1.2 General Plant Description

The information in this section of the reference ABWR DCD, including all subsections, tables, and figures, as modified by the STP Nuclear Operating Company Application to Amend the Design Certification rule for the U.S. Advanced Boiling Water Reactor (ABWR), "ABWR STP Aircraft Impact Assessment (AIA) Amendment Revision 3," dated September 23, 2010 is incorporated by reference with the following departures and supplements.

Figure 1.2-1 Site Plan

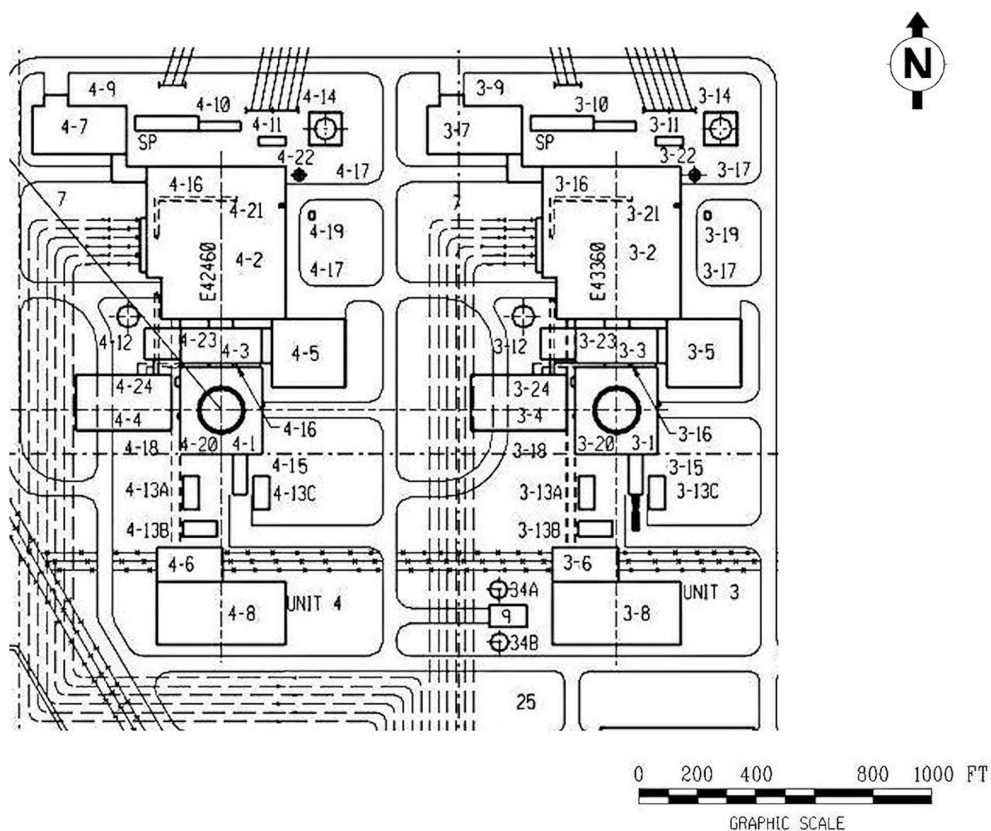
STP DEP 1.1-2 (Figure 1.2-1)

The containment and building arrangements, including equipment locations, are shown in Figures 1.2-2 through 1.2-37. The arrangement of these structures on the plant site is shown in Figure 1.2-1.
